VSH PREMIER CIRCLE ARB 2022-29

SUBMISSION OF FINAL SITE PLAN

June 21, 2022

PROJECT NARRATIVE

DEMOLITION PLAN

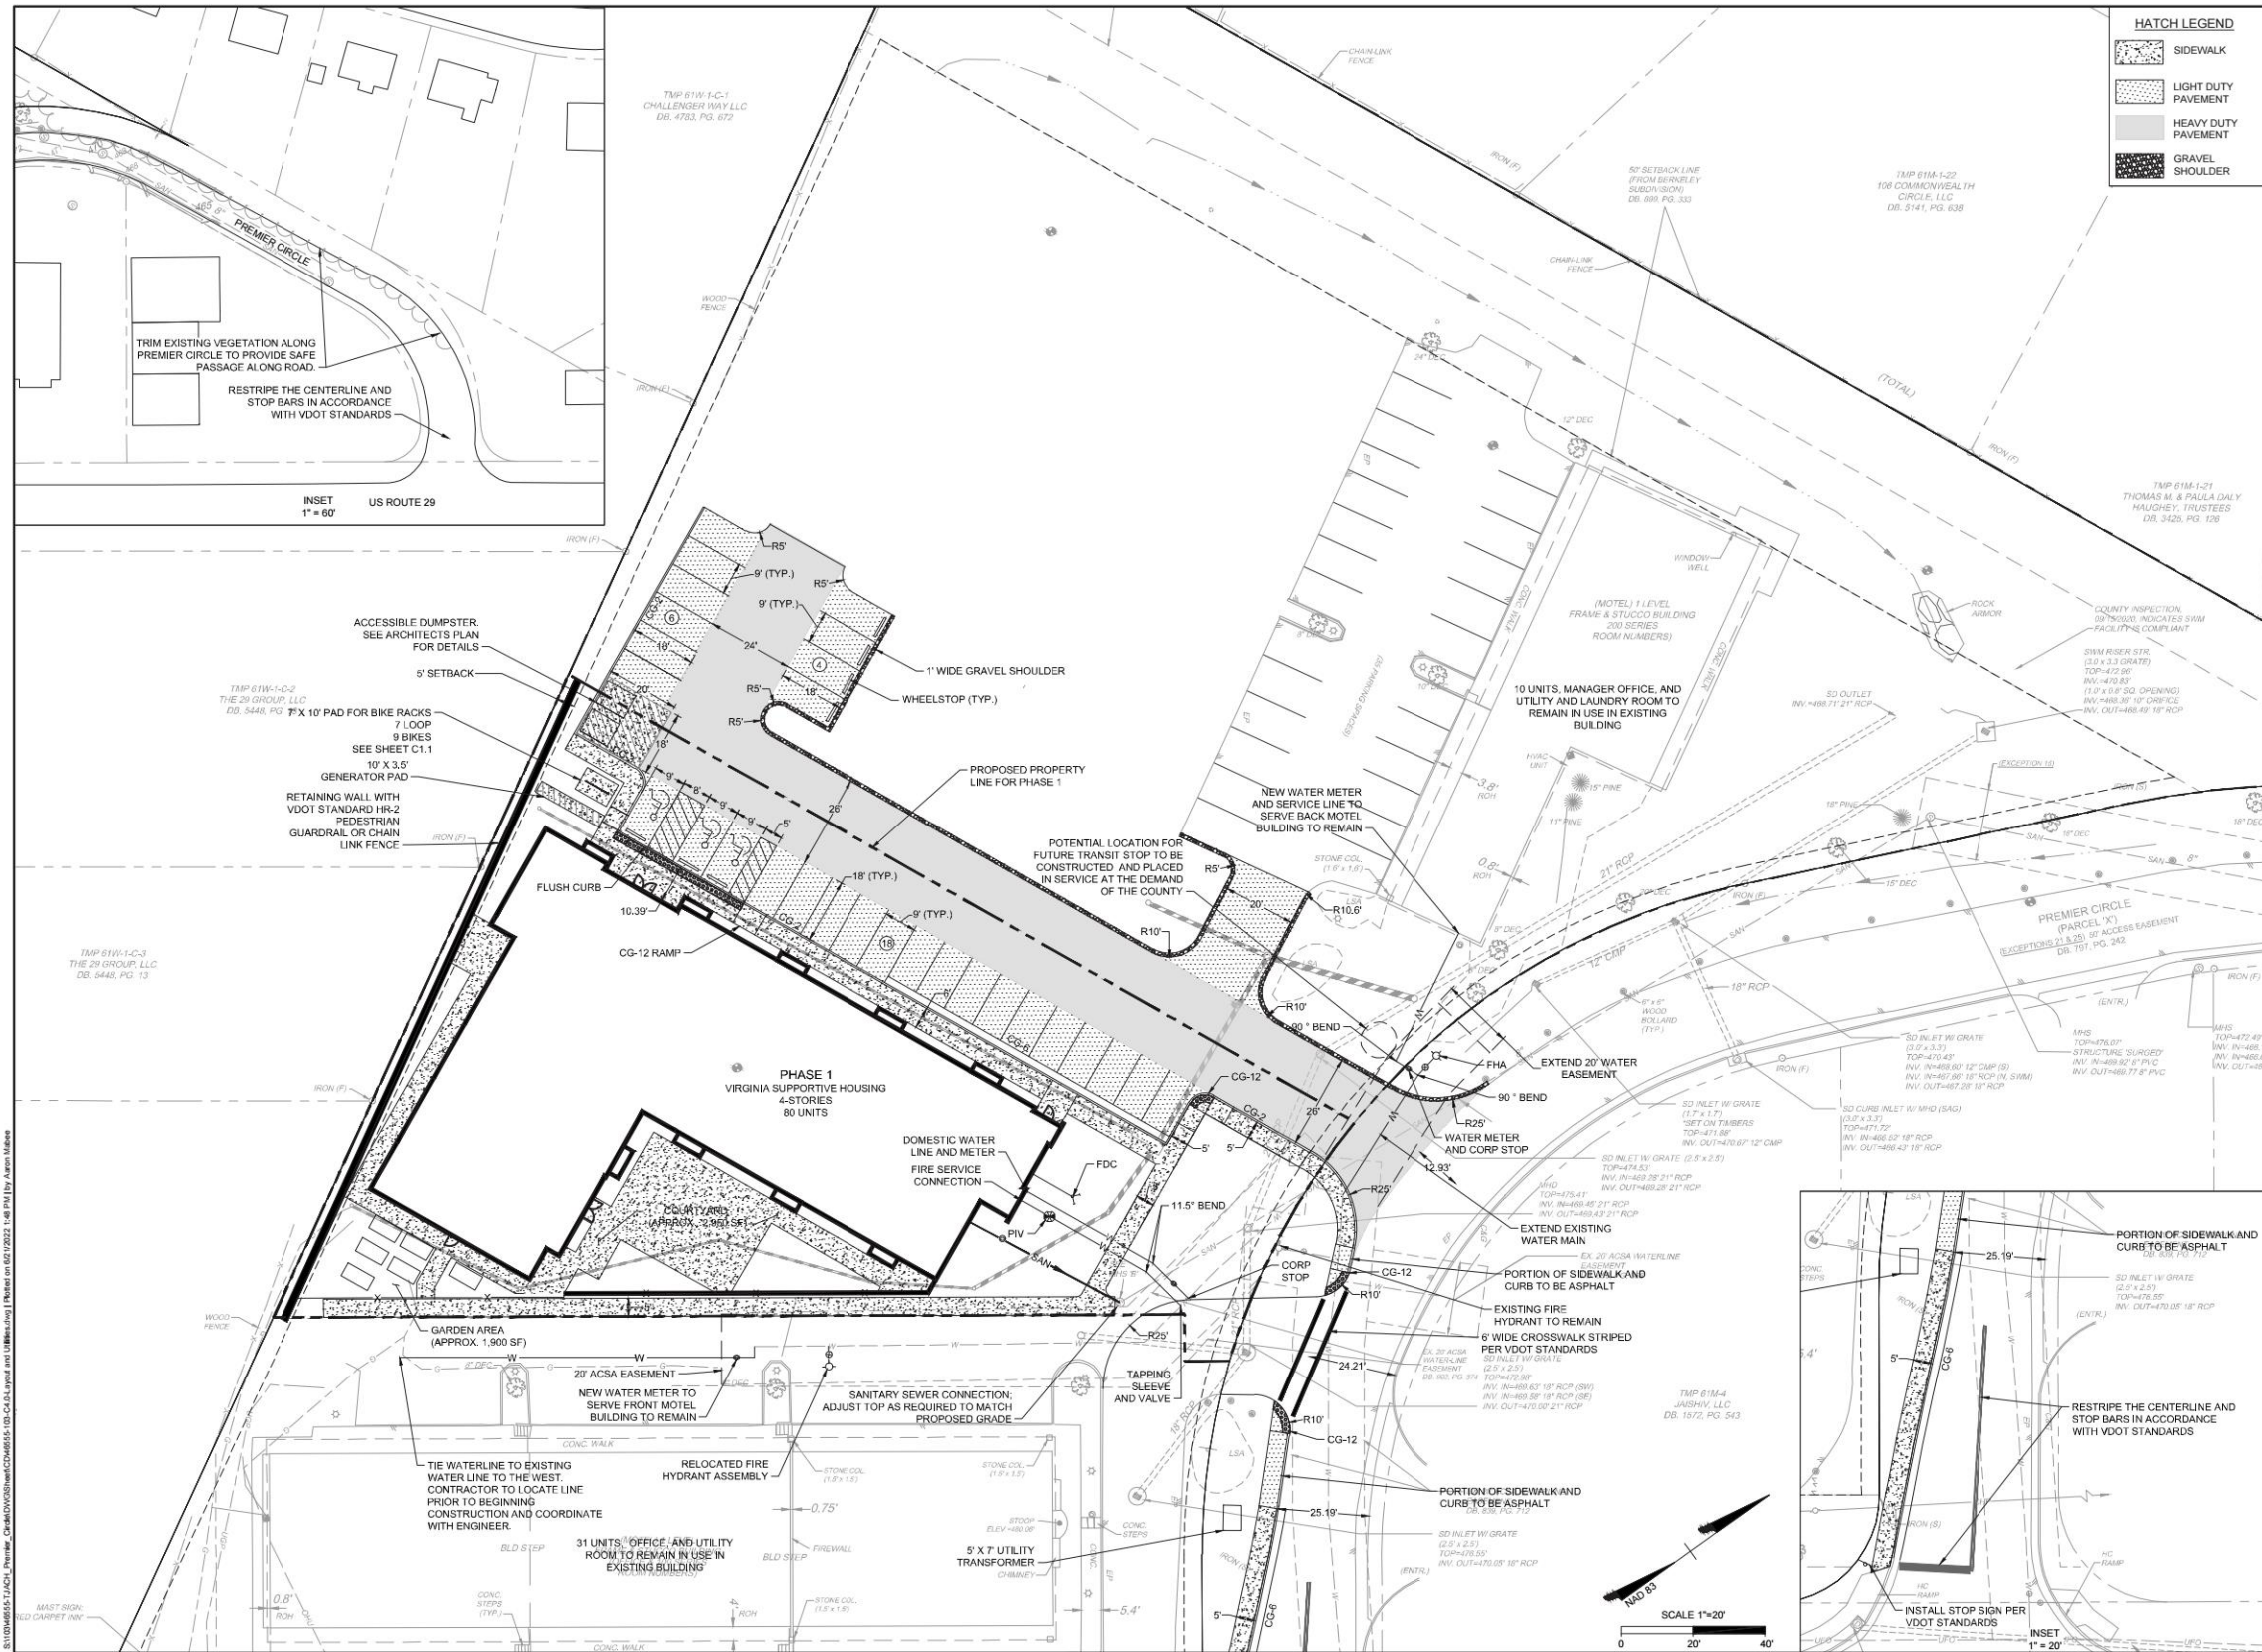
4. **Revise the site plan set to include a phased demolition plan**
 Demolition plan provided to left. This Final Site Plan is being submitted with a demolition plan for this first phase of construction. Future phases will have Final Site Plans with demolition plans. See Final Site Plan.

PROPOSED SITE PLAN

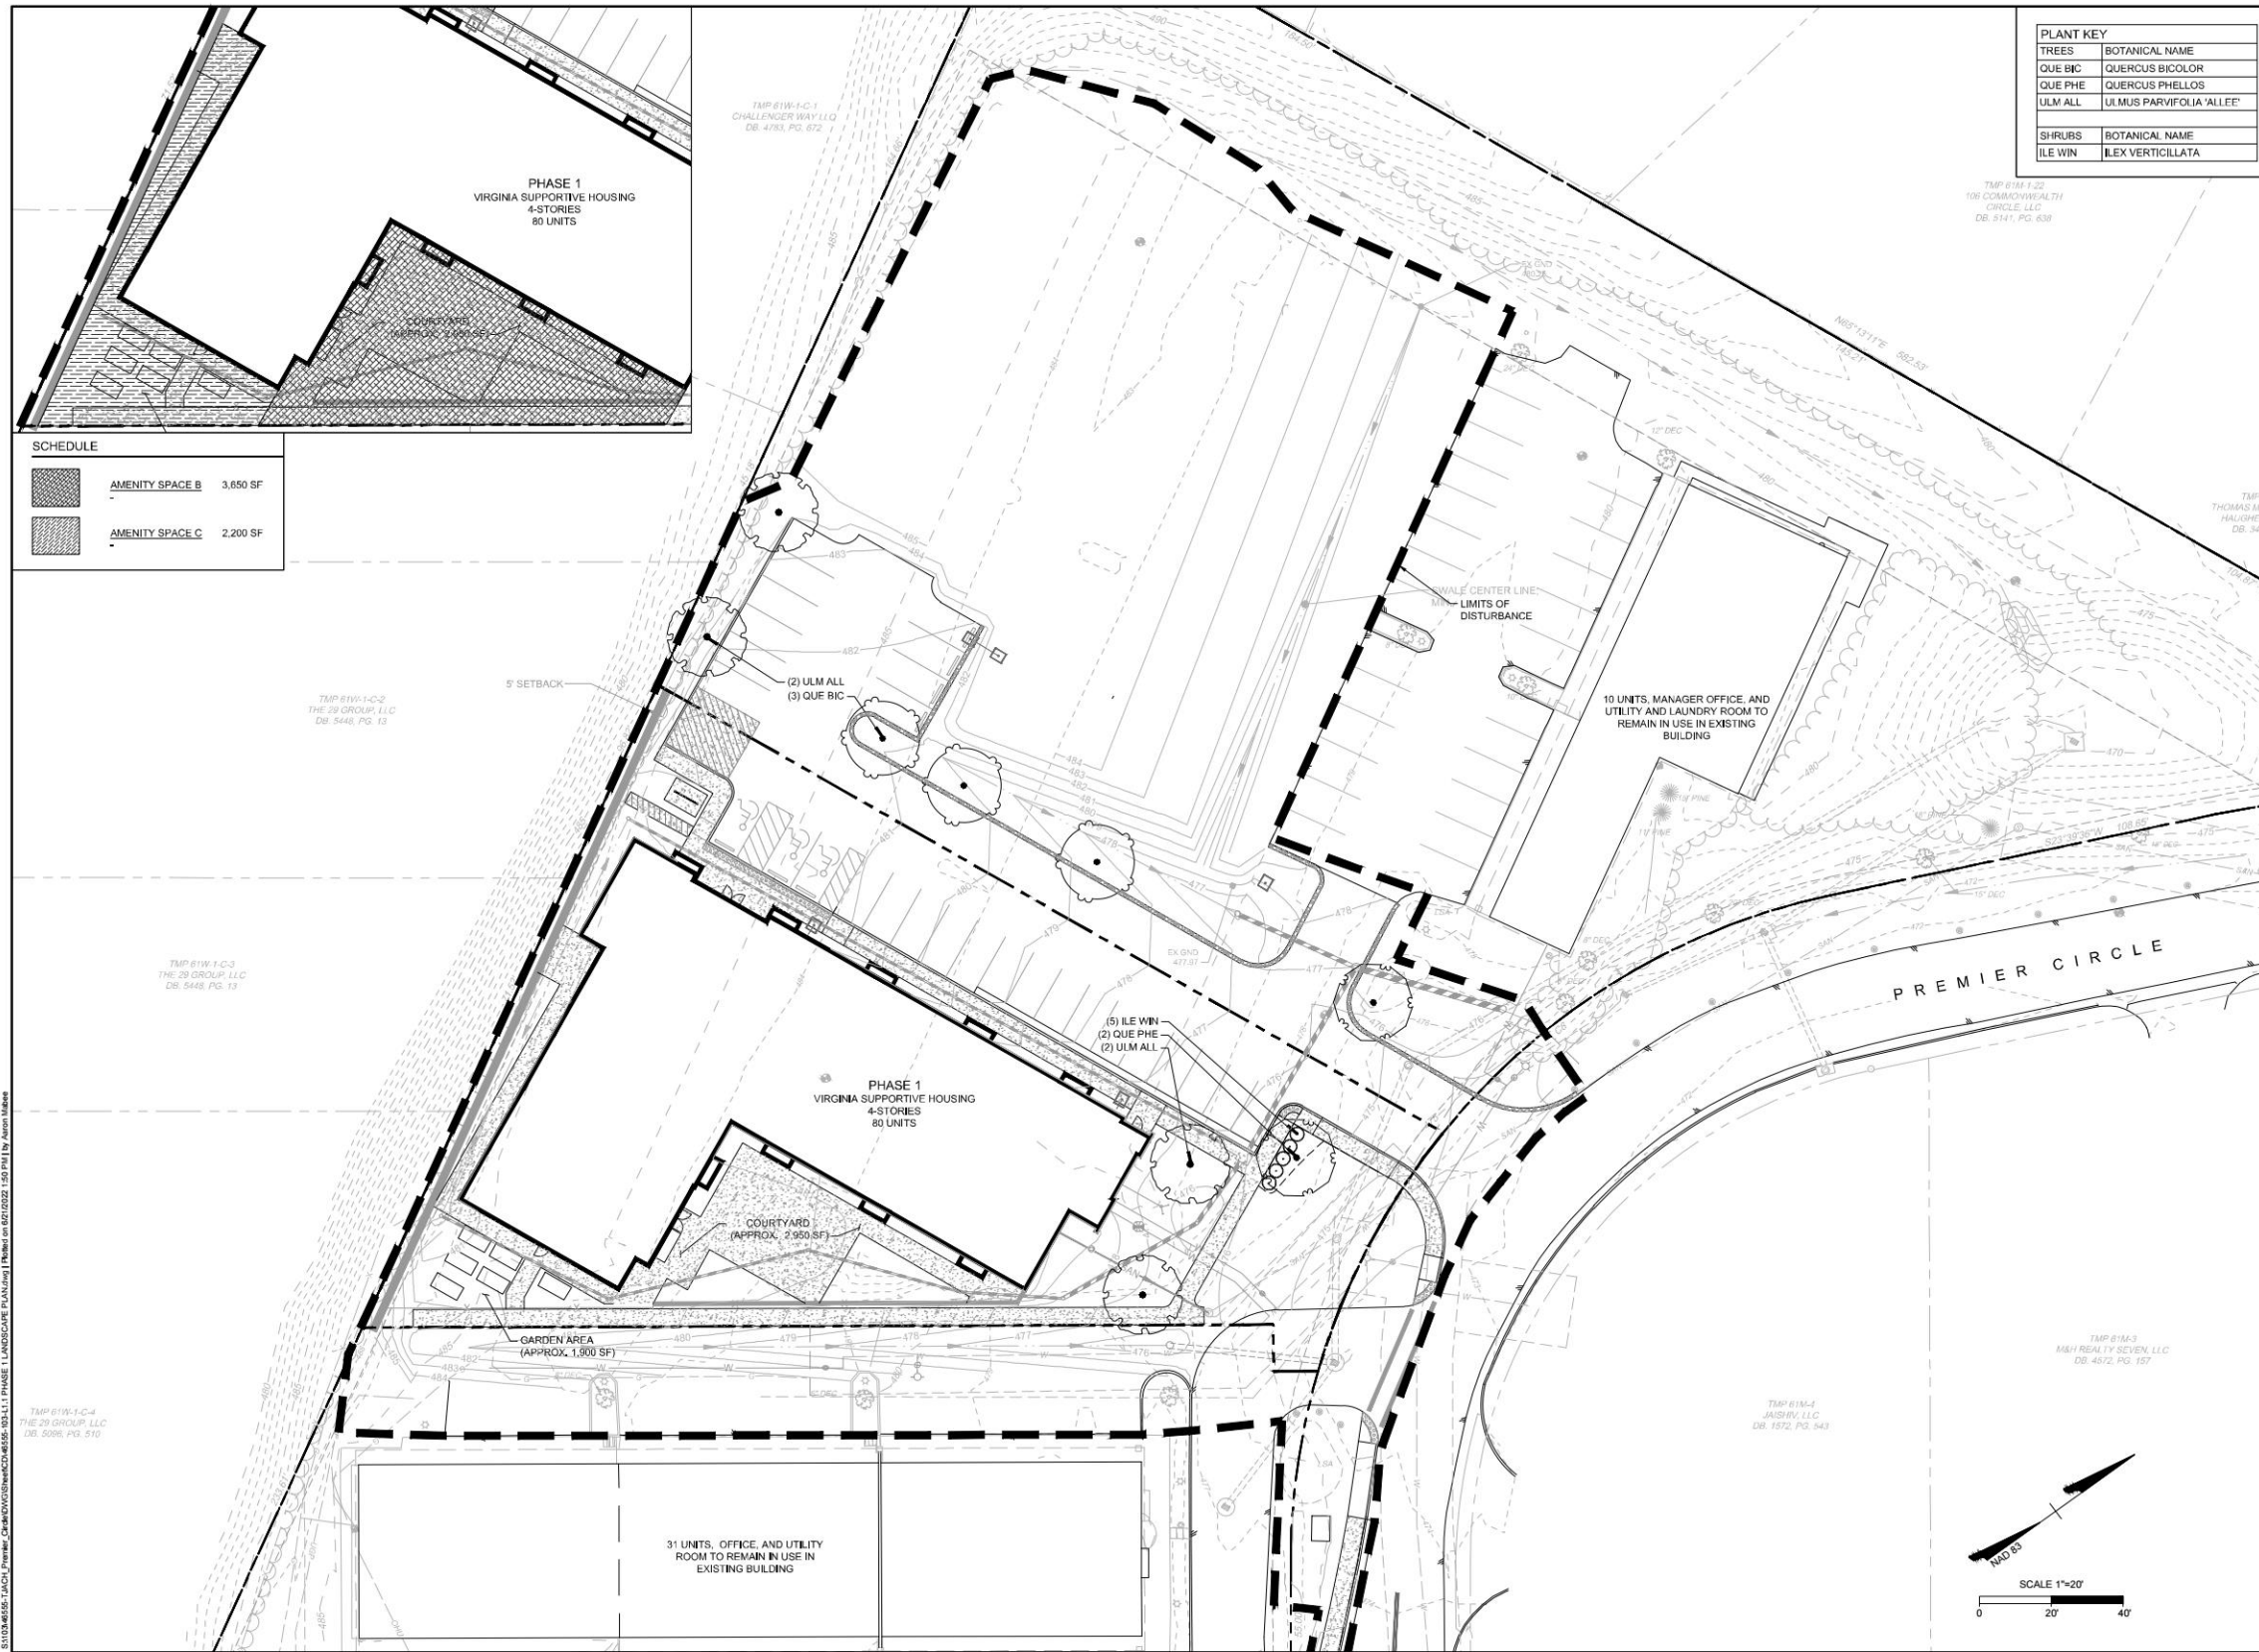
5. **Revise the site plan set to include the limits of work for each phase of the development**
This Final Site Plan is being submitted with for this first phase of construction. Future phases will have Final Site Plans for those phases. See Final Site Plan.

15. **Revise the site plan to show the limits of work for Phase 1 of the development. Show tree protection fencing on, and coordinated throughout, the grading, landscaping, and erosion and sediment control plans where needed.**
Site plan revised to show limits of work for phase 1. See Final Site Plan.

LANDSCAPE PLAN

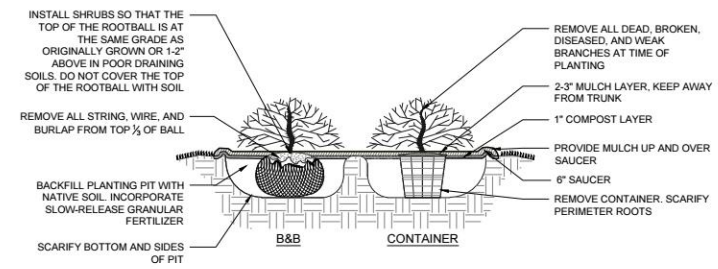
14. Revise the landscape plan to provide additional trees to meet the interior parking area landscaping requirements (one tree for every 10 spaces evenly distributed) Landscape plan revised. Proposed trees meet the landscaping requirements and are located in such a way that they will not be affected by later phases. See Final Site Plan.
